UNITED STATES PATENT AND TRADEMARK OFFICE

APPLICATION NO.	FILING DATE	FIRST NAMED INVENTOR	ATTORNEY DOCKET NO.	CONFIRMATION NO.
10/797,003	03/11/2004	Akiji Shibata	503.43552X00	3868
20457	7590	08/07/2006	EXAMINER	
ANTONELLI, TERRY, STOUT & KRAUS, LLP 1300 NORTH SEVENTEENTH STREET SUITE 1800 ARLINGTON, VA 22209-3873			CHAMBLISS, ALONZO	
			ART UNIT	PAPER NUMBER
			2814

Office Action Summary

DETAILED ACTION

FIG. 9

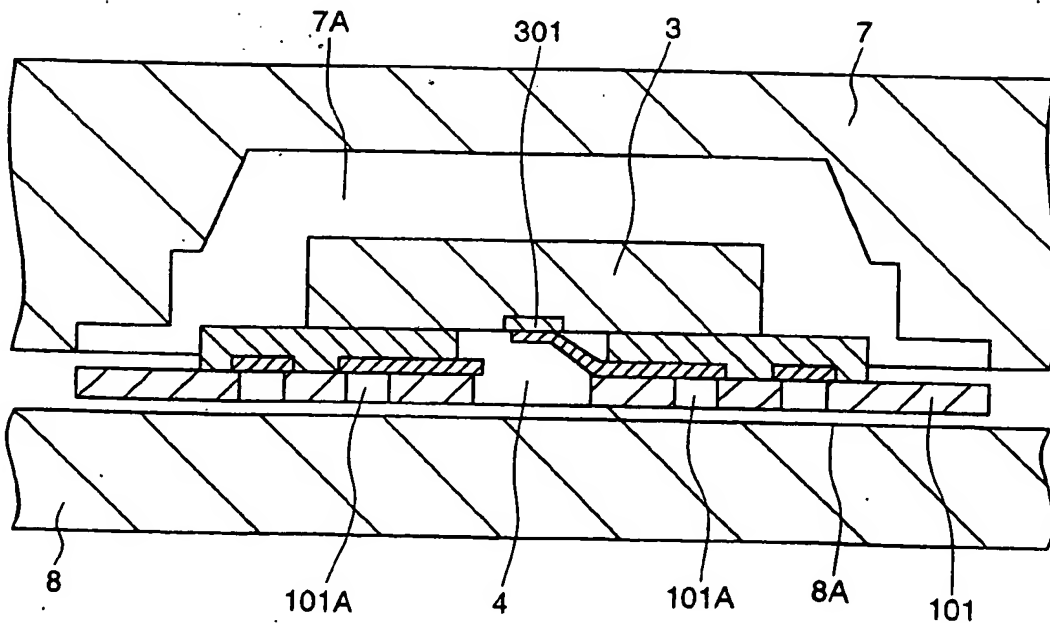
2. The drawings were received on 2/13/06. These drawings are partially approved. The replacement sheet for Figs. 9 and 10 are approved but the replacement sheet for Figs. 11 and 12 are not approved since the "Prior Art" label is still missing above the figures.

Approved
AC
7/25/06

FIG. 11

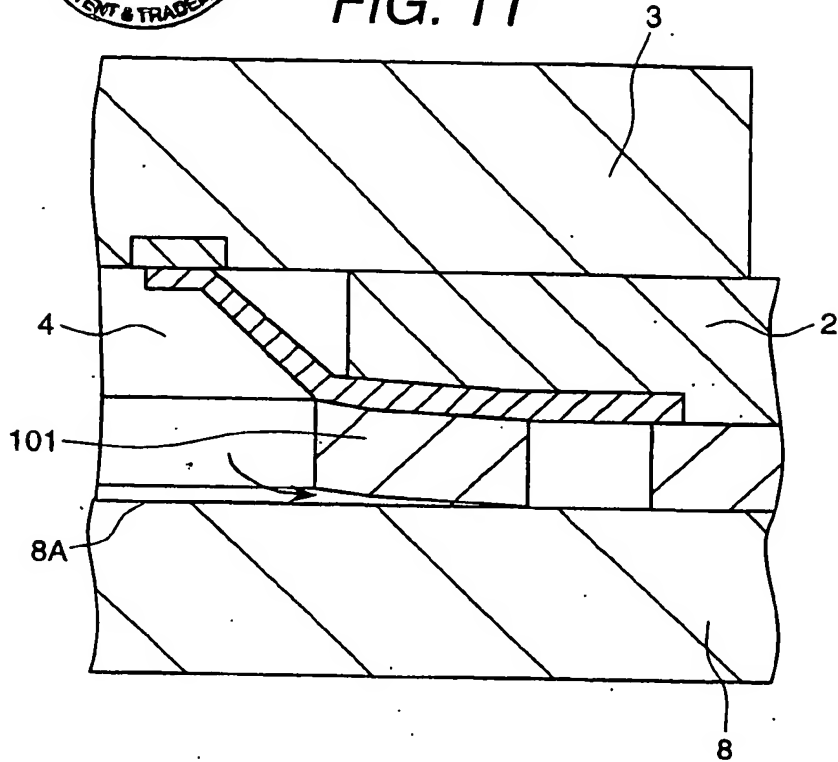
3. Figures 11 and 12 should be designated by a legend such as --Prior Art-- because only that which is old is illustrated. See MPEP § 608.02(g). Corrected drawings in compliance with 37 CFR 1.121(d) are required in reply to the Office action to avoid abandonment of the application. The replacement sheet(s) should be labeled "Replacement Sheet" in the page header (as per 37 CFR 1.84(c)) so as not to obstruct any portion of the drawing figures. If the changes are not accepted by the examiner, the applicant will be notified and informed of any required corrective action in the next Office action. The objection to the drawings will not be held in abeyance.
